CITY OF ALBUQUERQUE

Starbucks, 4407 Lomas Blvd. Grading and Drainage Plan

Engineer's Stamp Date 3-27-2015 (File: J17-D012)

GRADING & DRAINAGE PLAN

Date:	No.	Revision:	Date:	Job No.
03/21/15				2115
Drawn By:				
DEC/BJB				CG-101
•				
Ckd By: FCA				SH. OF
FCA				Sn. Or

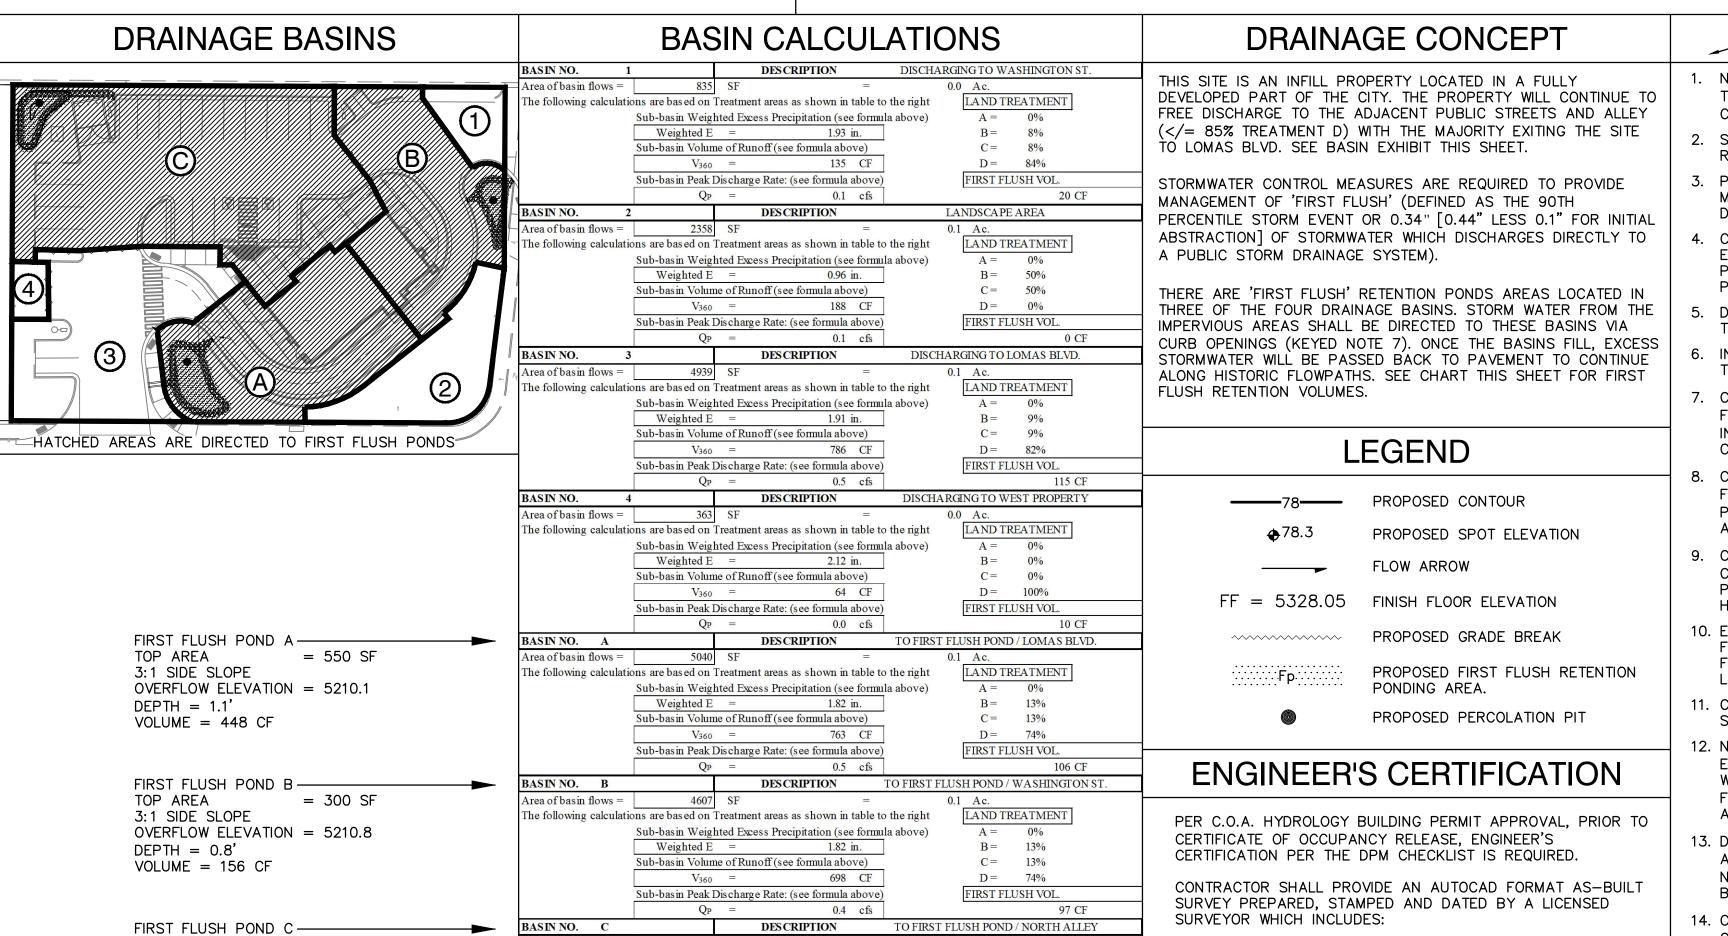
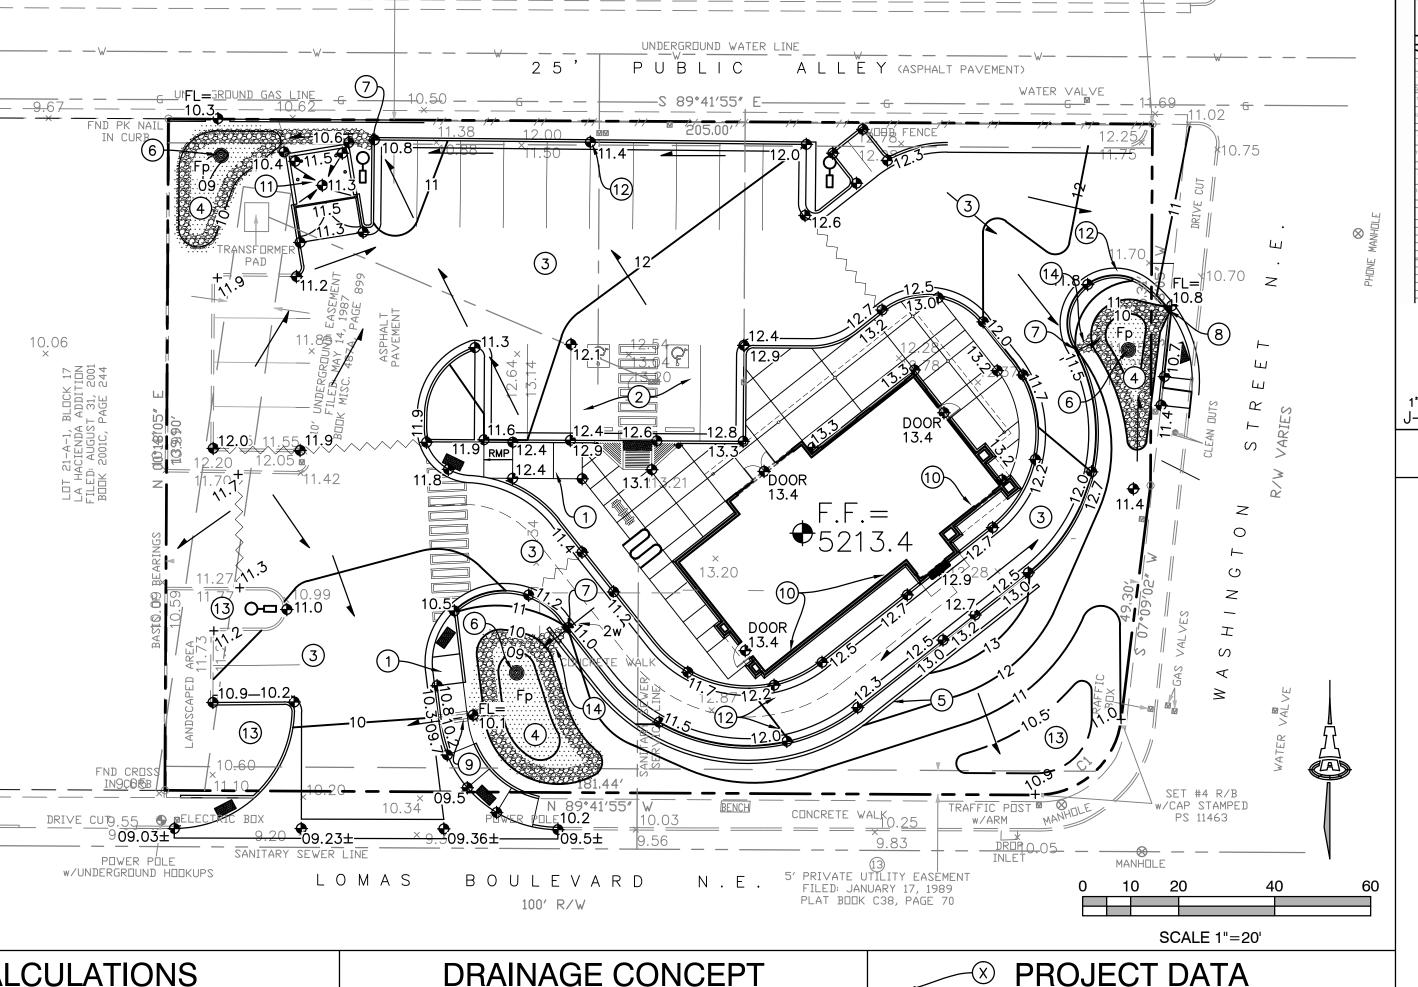
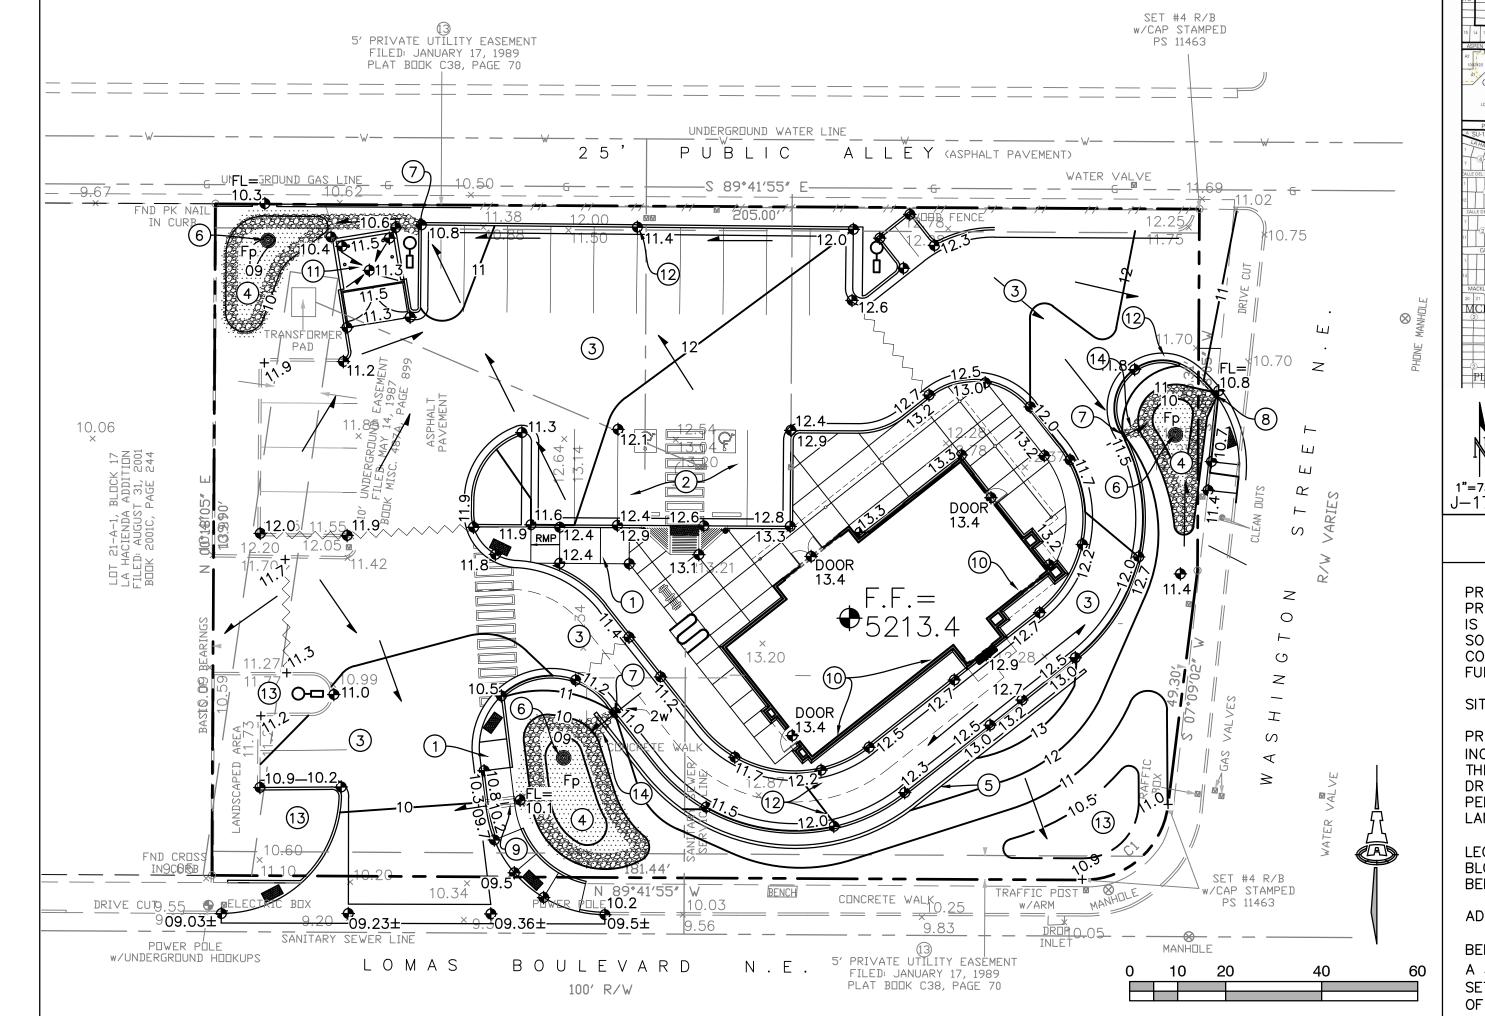
1) Under the Basin Calculations, label the associated impervious area next to the first flush volume for each of the basins. At the bottom end of the Basin Calculations Table, show the total proposed 100-year flow, the total of the impervious areas, and the total of the first flush volume.

2) Provide calculations for the existing 100-year flow for comparison to the proposed 100-year flow.

3) For each of the first flush retention ponding areas, label the volume that is being retained. Show capacity of each of the on-site sidewalk culverts and the flow that it is capturing.

4) Address any off-site impacts due to site grading with regard to the site immediately adjacent to the Starbucks site.
